Subdivision and Land Development Cover
Page for SLD # 08-24

Project Name: Mercedes Lot Consolidation

Address: 401 Bethlehem Pike & 404
Pennsylvania Ave, Ft. Washington, PA 19034

Reference: Minor Subdivision Plan Review
401 Bethlehem Pike & 404 Pennsylvania Avenue
Whitemarsh Township, Montgomery County, Pennsylvania
SLD #08-24

SHEET TITLE:
LOT CONSOLIDATION PLAN
SHEET NUMBER:
LC-01
ORG. DATE - 12/03/2024

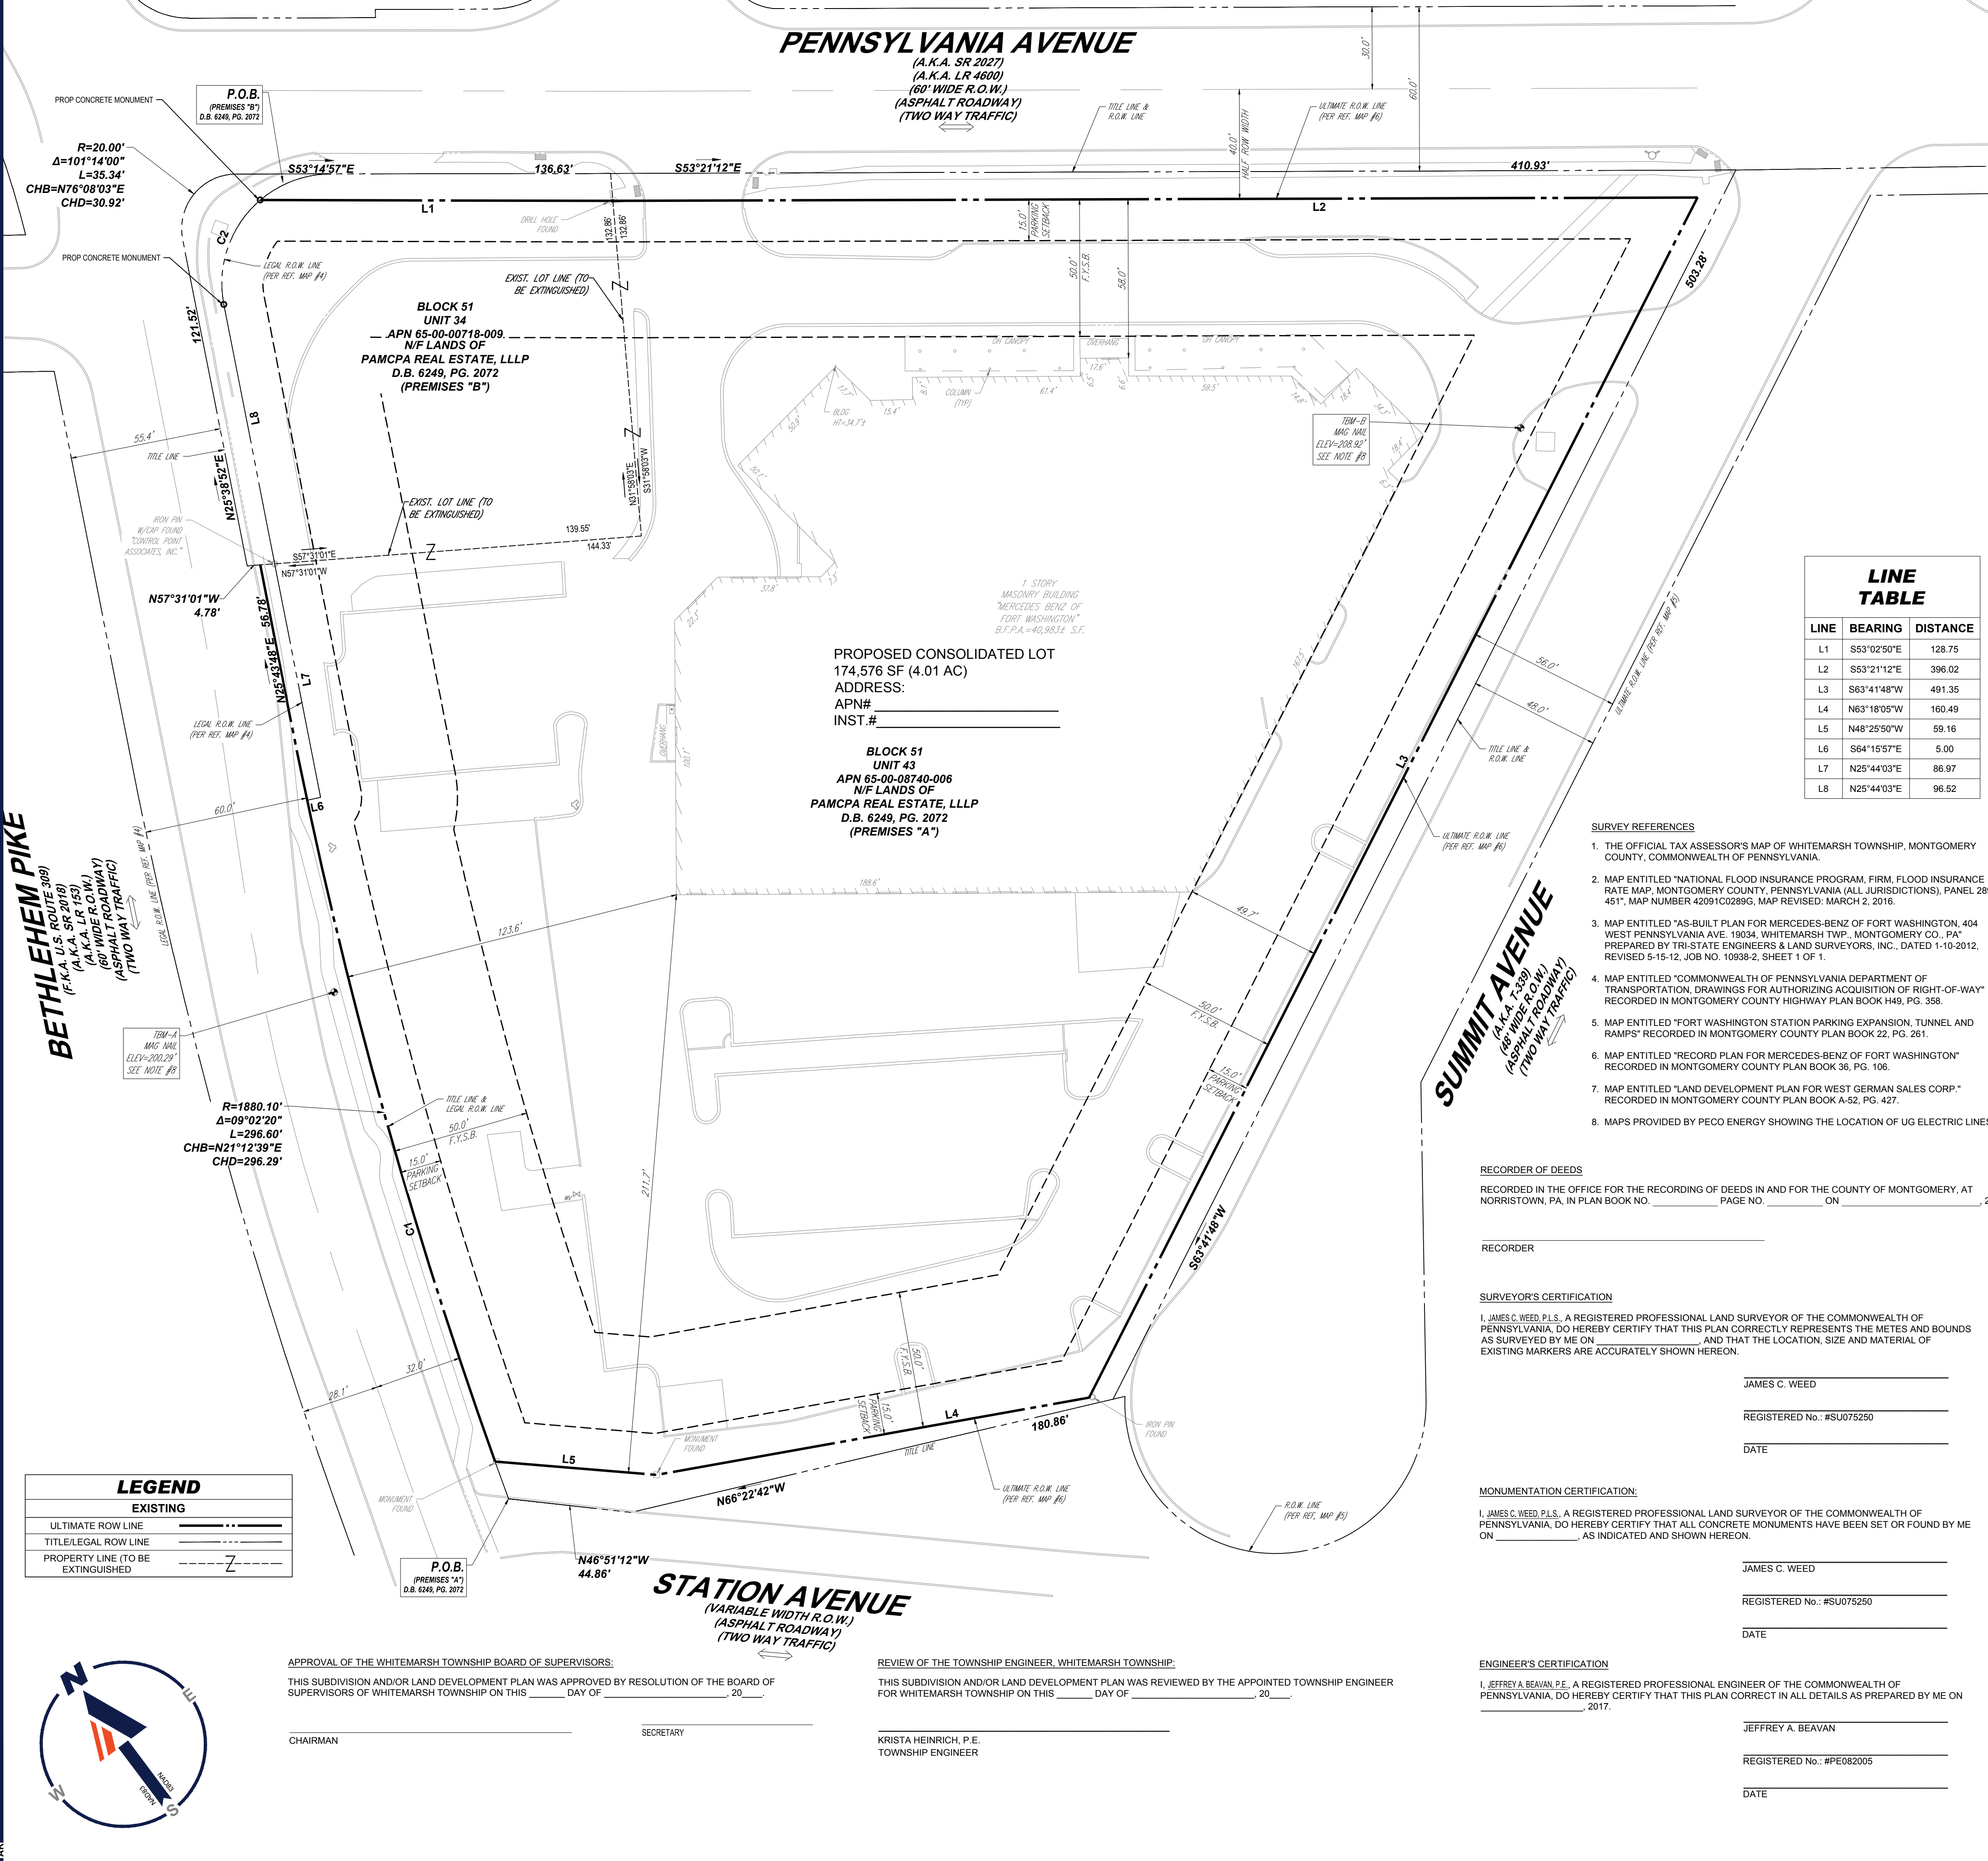
<u>Section</u>	<u>Description</u>
18. 105-23(A)(1)	A waiver must be obtained to allow the plans to be drawn at a scale of 1"=30 feet, where this section of the ordinance requires that the plan shall be drawn at a scale of one inch equals 50 feet or one inch equals 100 feet.

19. 105-38(A)	The plans must be revised to include dimensions for the parking areas on Block 51, Unit 34, in order to demonstrate compliance with the requirements of this section of the ordinance. A waiver may be required in order to permit existing parking areas to remain as is.

20. 105-38(I)	The plans must be revised in order to demonstrate compliance with the requirements of this section of the ordinance, which states that no more than 15 parking spaces shall be permitted in a continuous row without being interrupted by a landscaping area not less than the width of a parking space constructed in accordance with the plan. A waiver may be required in order to permit existing parking areas to remain as is.

21. 105-38(J)	The plans must be revised in order to demonstrate compliance with the requirements of this section of the ordinance, which states that no one area for off-street parking of motor vehicles shall exceed 30 cars in capacity. Separate areas on a parcel shall be physically separated from one another by ten-foot-wide planting strips. A waiver may be required in order to permit existing parking areas to remain as is.

22. 105-38(K)	The plans must be revised in order to demonstrate compliance with the requirements of this section of the ordinance, which states that parking lots with less than 30 spaces shall not have a grade exceeding 5% and parking lots with more than 30 spaces shall not have a grade exceeding 3%. A waiver may be required in order to permit existing parking areas to remain as is.

<u>Section</u>	<u>Description</u>
23. 105-38(O)	The plans appear to show parking areas located within 10 feet from any building or structure, and therefore a waiver would be required. The granting of any waiver should be conditioned on the approval of the Fire Marshal.

25. 105-48	This section of the ordinance requires the installation of street trees along all streets where suitable trees do not exist. Large street trees shall be planted at intervals of not more than 45 feet, and/or small street trees at intervals of not more than 30 feet along both sides of new streets and along one or both sides of any existing street within the proposed land development. The plans must be revised or a waiver must be obtained.

<u>Section</u>	<u>Description</u>
26. 105-23(B)(4)(g), 105-23(B)(1)(d)[6]	The plans must be revised to Reference ZHB Decision 2010-24, ZHB Decision 2014-11, and Resolution 2011-10, which granted relief from various sections of the Township Code as part of prior applications.

19. From SALDO §105-23(A)(1) to permit a plan scale of 1" = 30' where 1" = 50' is required, in order to show greater detail on the plan set.
20. From SALDO §105-23(B)(1)(d)[5] from the requirement to show steep slope ratio with supporting calculations, as the application is only for a lot consolidation of two (2) existing, developed parcels, and no additional development is proposed.

23. From SALDO §105-38(I), from the requirement that no more than 15 parking spaces shall be permitted in a continuous row without being interrupted by a landscaping area not less than the width of a parking space constructed in accordance with the plan. A waiver is requested in order to permit existing parking areas and inventory storage areas to remain as is.

24. From SALDO §105-38(J), from the requirement that no one area for off-street parking of motor vehicles shall exceed 30 cars in capacity, and that separate areas on a parcel shall be physically separated from one another by ten-foot-wide planting strips. A waiver is requested in order to permit existing parking areas and inventory storage areas to remain as is.
